## King County

RE: Site Channel Migration Hazard Assessment, Parcel No. 3323069068, Scrivner Property

### **Geotechnical Report Review**

Figure 2. Site Map from geotechnical report (Aspect 2018). Test pits where Aspect identified bedrock are shown in purple.

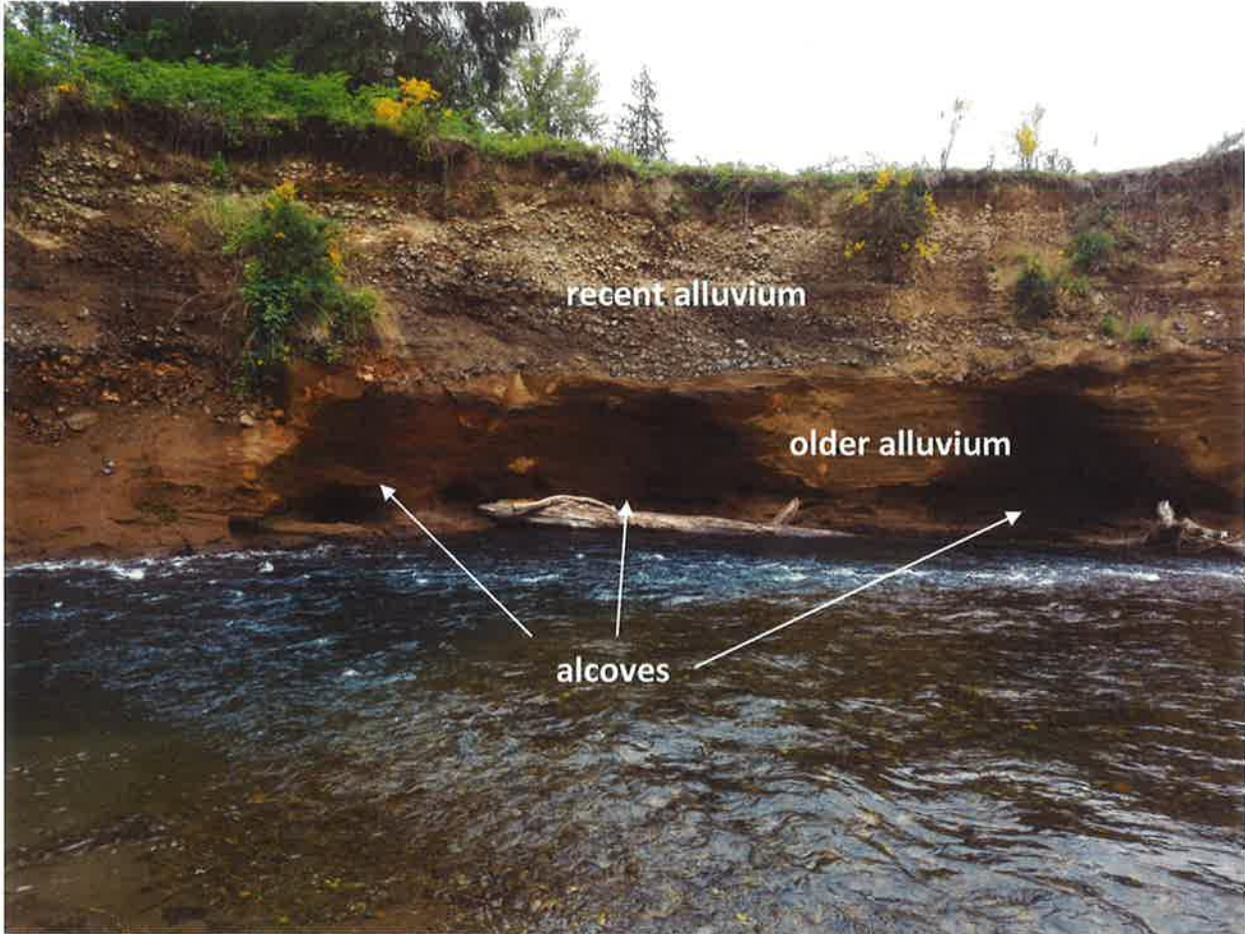
The channel migration hazard assessment (the Report) submitted on behalf of the property owner consists of a description of site conditions, a brief discussion of channel migration hazards, an assessment of erosion and landslide hazards, and conclusions and recommendations regarding the County's CMZ and associated slope stability hazards. Use of the King County CMZ Public Rule Appendix A methodology is implied by the Report's reference to and acceptance of King County's (2015) delineation of historical migration zones, avulsion hazard zones, reach-average lateral migration rates, and reach-average erosion setback distances. However, the Report does not itself apply the required methods and criteria as specified in Appendix A of the adopted 2018 Public Rule. The Report disputes the applicability of the reach-average erosion rates to the site on the basis of the presence in several test pits (Figure 2) of an excavation-resistant material, which was inferred to be highly erosion-resistant Renton Formation (Tertiary age) bedrock. The Report claims that this material constitutes the river banks at the site, and therefore that no erosion or geotechnical setback is appropriate.

Based on these observations and tests, we concluded that the material exposed on the lower portion of the river bank is likely to be compacted “older alluvium” as mapped and as described by Booth (1995). Given its elevation and extent, this is likely the same material as was encountered in the test pits and described as Renton Formation bedrock by Aspect. Regardless of its origins or proper name, however, the material exposed in the riverbank is not completely resistant to erosion by the river, but it is less erodible than the recent (Holocene) alluvium that overlies it.

This condition applies to this site where the erosion-resistant material has been exposed by river action, and also where it is present at the level of the river but not currently exposed at the river’s edge, as discovered in the test pits.

RFMS staff conducted independent site investigations and a review of the aerial photograph record, and determined that the submitted report's conclusion that the material is completely resistant to erosion is not warranted by site conditions or history. Therefore, a complete elimination of the Erosion Setback portion of the CMZ would be inappropriate. However, RFMS also determined that a revision of the existing effective CMZ mapping would be appropriate based upon incorporating a partial reduction of the erosion setback in light of site-specific information gained during site visit.

Figure 6. Location of transects used to calculate bank retreat distances and erosion rates. Graphic includes current effective CMZ Severe and Moderate hazard boundaries.

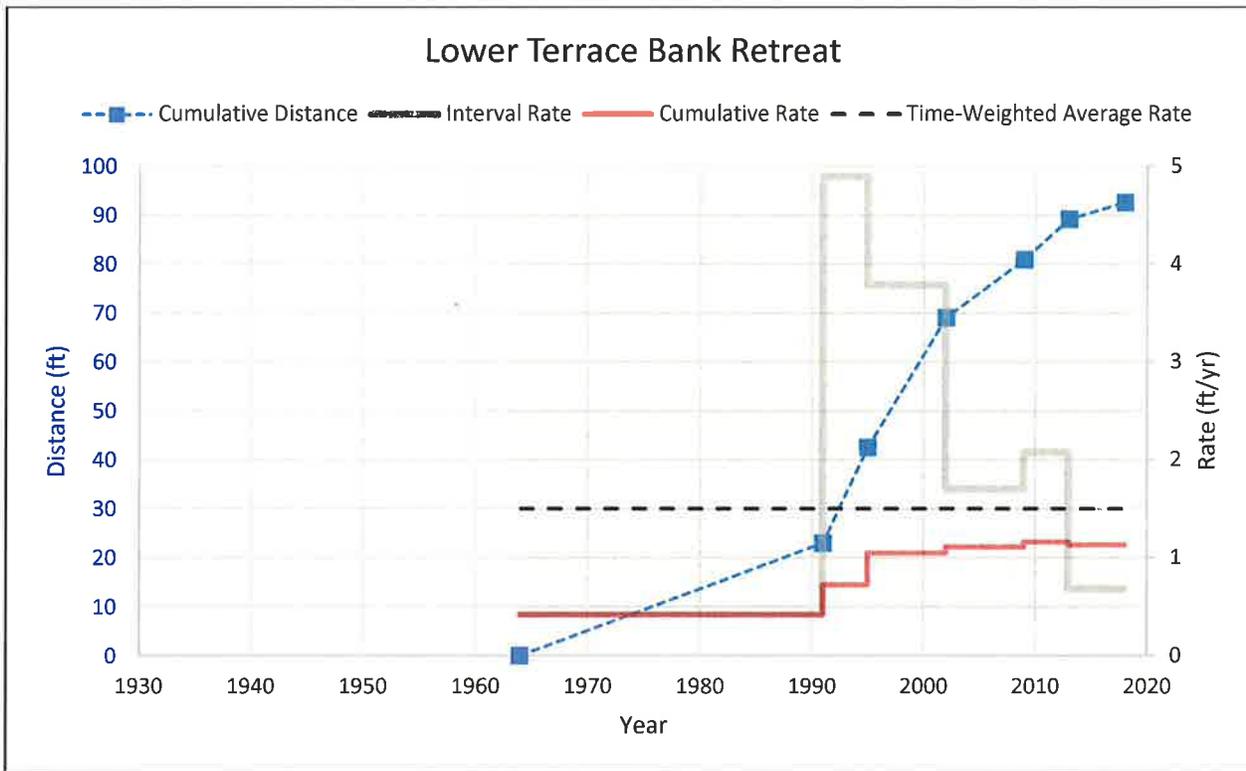
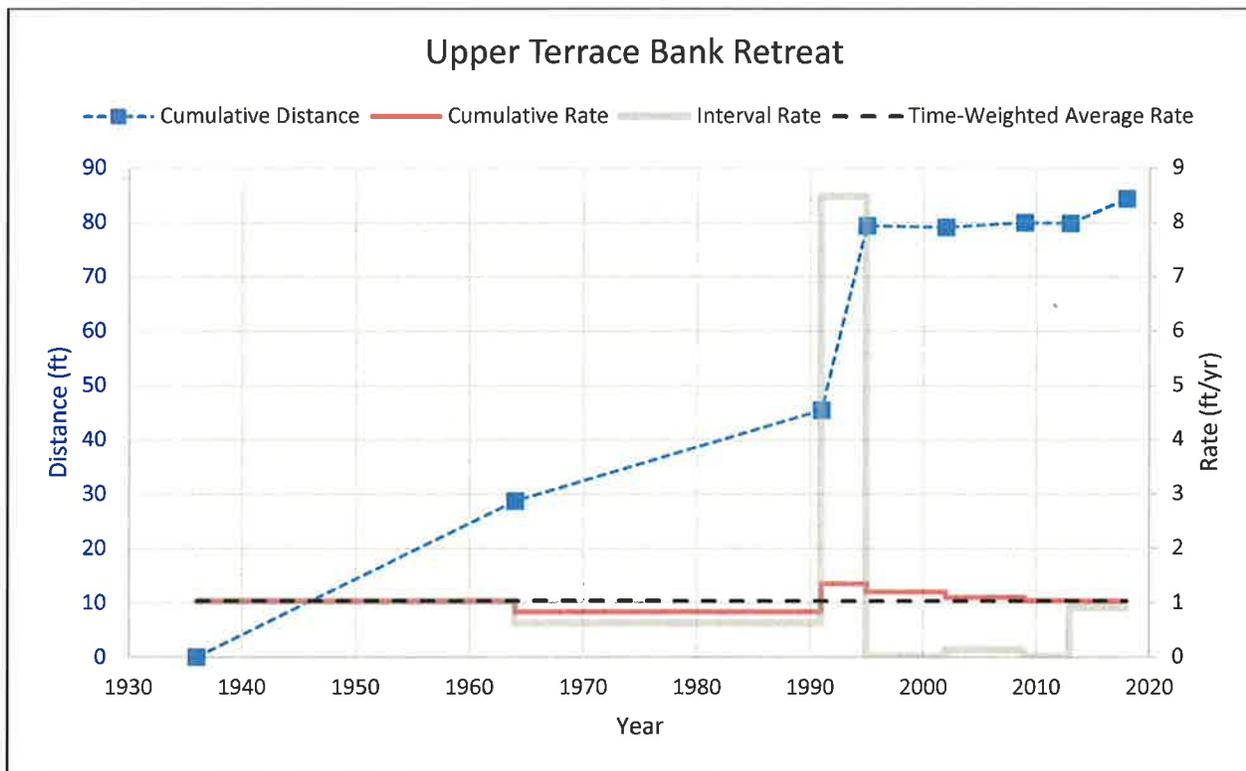
To determine the appropriate erosion rate for this location, RFMS staff used the 1936 to 2018 aerial photograph record to measure bank retreat distances and calculate erosion rates along two transects perpendicular to the river bank where the erosion-resistant material was exposed; one extending into the upper terrace and one into the lower terrace as shown in Figures 4 through 6. Results are presented in Figure 7. The erosion rates measured when the river was eroding into the upper terrace (with a greater thickness of erosion-resistant material) were lower than those measured when the river was eroding into the lower terrace. Based on bank retreat distances measured between 1936 and 2018, we calculated time-weighted average lateral migration rates and compared them with cumulative and interval rates for both upper and lower terraces (Figure 7). These methods for calculating lateral channel migration rates are consistent with Appendix A of the King County Channel Migration Public Rule (King County 2018).

The time-weighted average rate for the upper terrace was calculated to be 1 foot/year, and for the lower terrace 1.5 feet/year. Both rates are close to the cumulative rates at this location over the 81-year historical record, and therefore appropriate for use in determining 25 to 100-year erosion setback distances.

The extent of the revised erosion setback for the site was calculated using the time-weighted average lateral migration rates of 1 foot/year into the upper terrace and 1.5 feet/year into the lower terrace. The boundary of the erosion setback for lateral migration was set at the greater of the following two distances:

Figure 8. Comparison of currently effective CMZ mapping with the proposed revised hazard area boundaries.

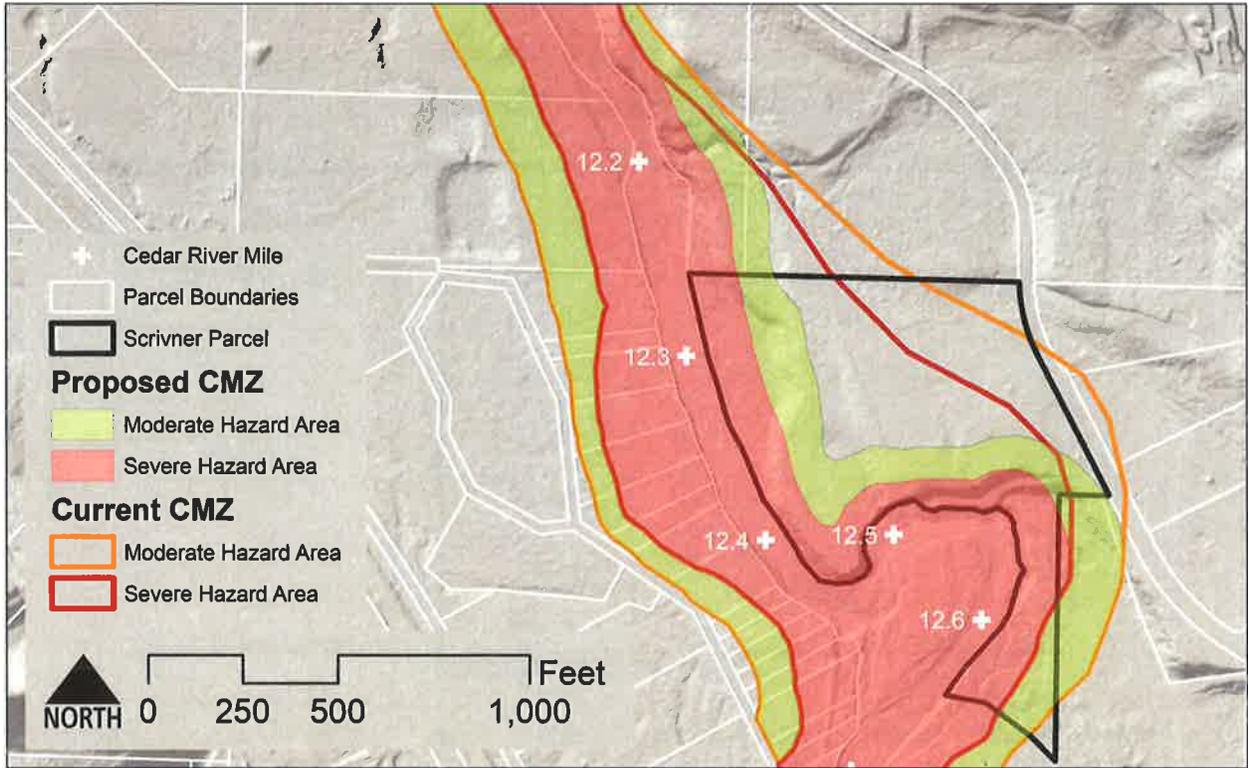
RFMS staff generated proposed revised mapping of the CMZ hazard areas along this portion of the Cedar River to reflect our reassessment of the 2015 adopted CMZ mapping. This proposed mapping was produced using GIS shapefiles to reflect this reassessment per the Public Rule; it also incorporates an enhanced, site-specific understanding of the physical conditions and applies recalculated erosion and geotechnical setbacks to the area on the right bank of the Cedar River where we determined the erosion-resistant material to be present, based on test pit results (Aspect 2018), our site observations, and surface topography. The proposed revised portion of the CMZ extends from RM 12.2 to 12.6 along the right bank of the Cedar River (Figure 8).

In accordance with the procedures set forth in Section 21A-24-279A.B.3 of the King County Channel Migration Public Rule, the RFMS is recommending a revision to the effective Cedar River CMZ hazard area mapping in the vicinity of the Scrivner parcel. The revised mapping would also affect other adjacent parcels along the right bank of the Cedar River as listed in Table 1. RFMS is providing this memorandum and will transmit the appropriate digital version of the proposed revised mapping to DLS in support of DLS's adoption of this reassessment.
